# Work Order ID 101947

Item Name: Crosstube Fwd High

DRAWING NO. D212-664-141	TITLE XTUBE ASSY (205/212/412 HI FWD)	REV. D	DART AEROSPACE LTD ENGINEERING ORDER		D.E.O. NO. D212-664-141-D-1	SHEET NO. SHEET 1 OF 2	SCALE NTS
DRAWN	CHECKED	MP	MFG. APPR.	R	APPROVED	MA	DE APPR.
DATE 11.04.07	DATE 11.07.11		DATE 11.04.12		DATE 11/04/12		DATE 11.04.12

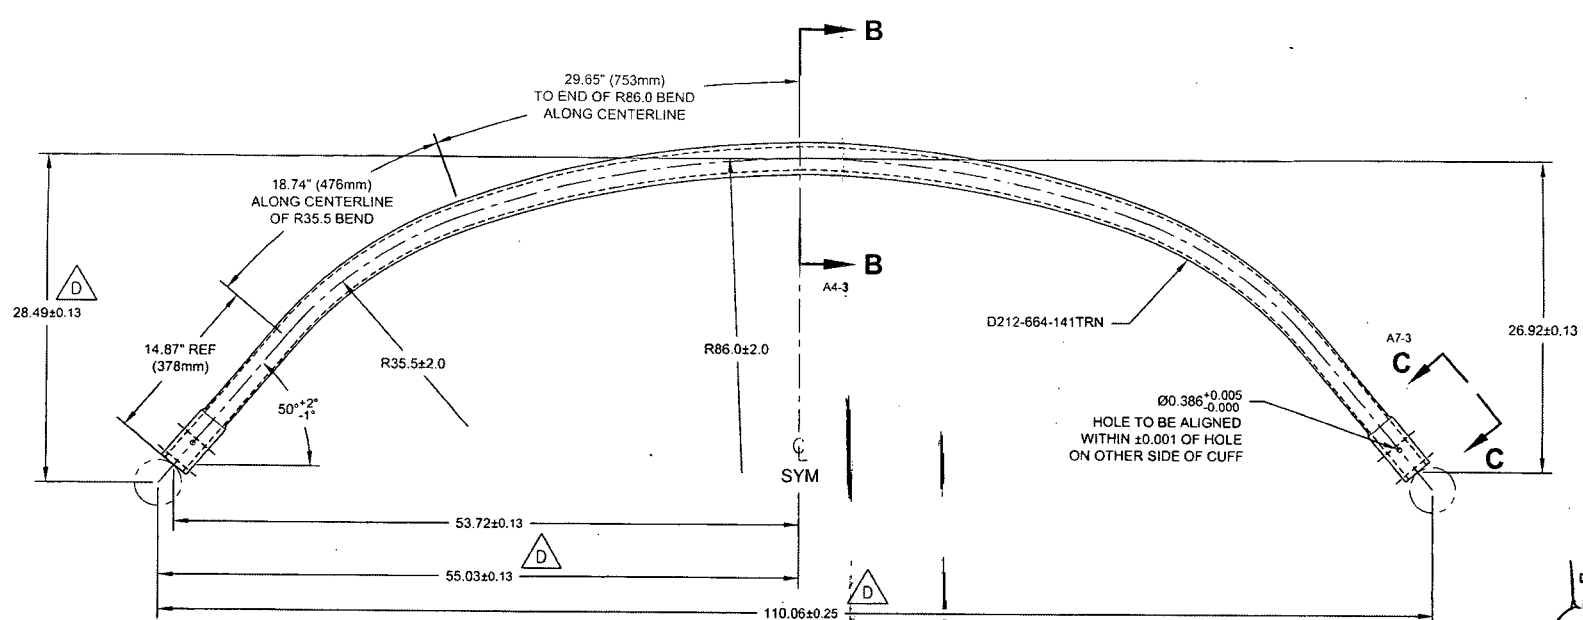
REPLACE MAGNOBOND WITH PROSEAL.

NOTE 12 & 15, SHEET 1 IS AMENDED AS FOLLOWS:

- 12) TO INSTALL D2893-1 SUPPORT: ABRASE MATING SURFACE OF SUPPORT AND CROSSTUBE WITH 180-GRIT SANDPAPER AND REMOVE RESIDUE WITH MEK (OR EQUIVALENT). APPLY A 0.04" TO 0.07" THICK LAYER OF PROSEAL 890 CLASS B-2 (OR AMS-S-8802 CLASS B-2) SEALANT TO MATING SURFACE OF SUPPORT.
- 15) TORQUE CLAMPS 80 TO 100 IN-LB. ENSURE AT LEAST 1.5 THREADS SHOWING IN SAFETY AND THAT NUT HAS NOT BOTTOMED-OUT AFTER TORQUING. **PRIOR TO PACKAGING, RE-CHECK TORQUE ON CLAMPS AFTER PROSEAL 890 SEALANT HAS CURED FOR 72 HOURS.**

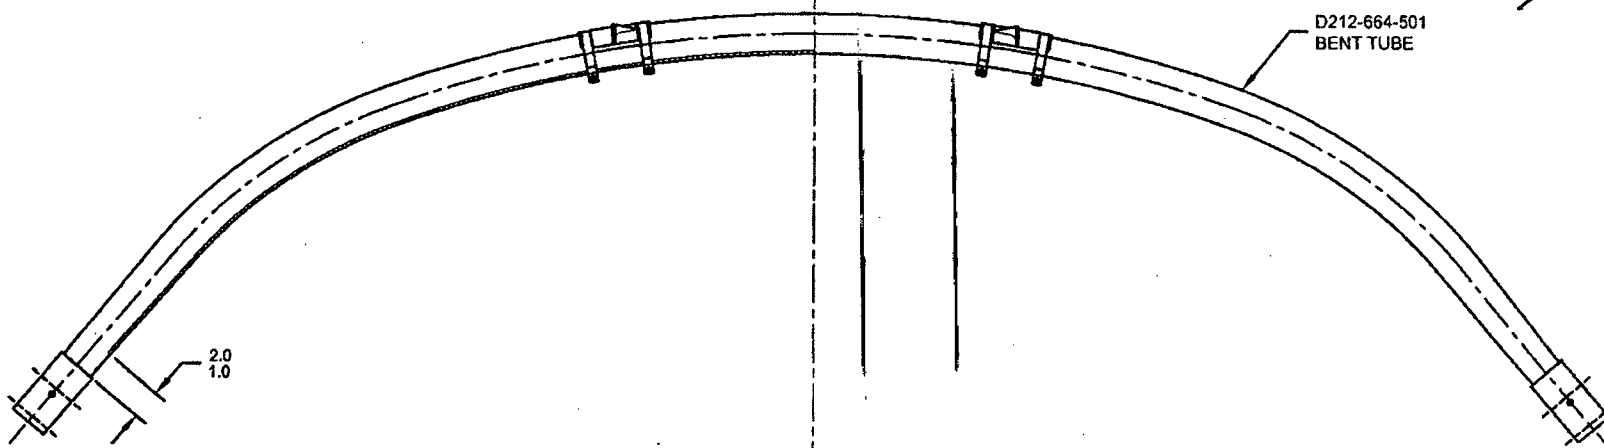
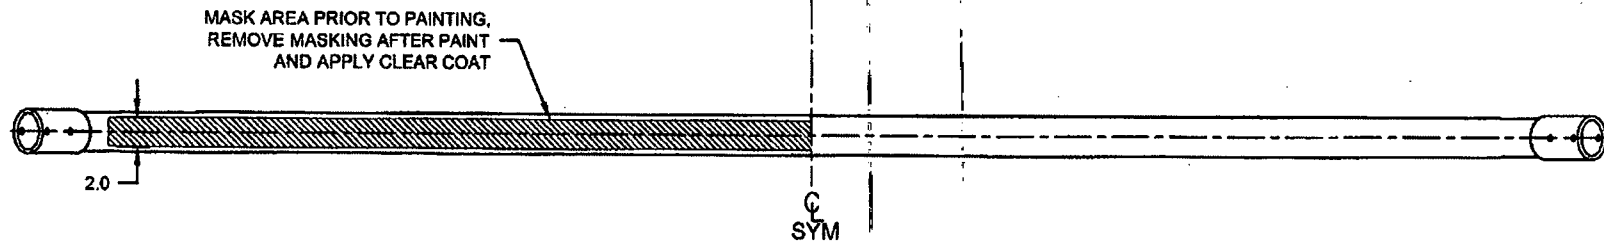
ADD AN INSPECTION WINDOW TO UNDERSIDE OF CROSSTUBE.

NOTES 2 OF SHEET 1 IS AMENDED AS FOLLOWS:

- 2) FINISH: CHEMICAL CONVERSION COAT PER DART QSI 005 4.1  
PRIME INSIDE AND OUTSIDE PER DART QSI 005 4.2  
MASK UNDERSIDE OF CROSSTUBE AS SHOWN (HATCHED AREA) AND  
PAINT OUTSIDE PER DART QSI 005 4.2  
REMOVE MASKING AND APPLY CLEAR COAT
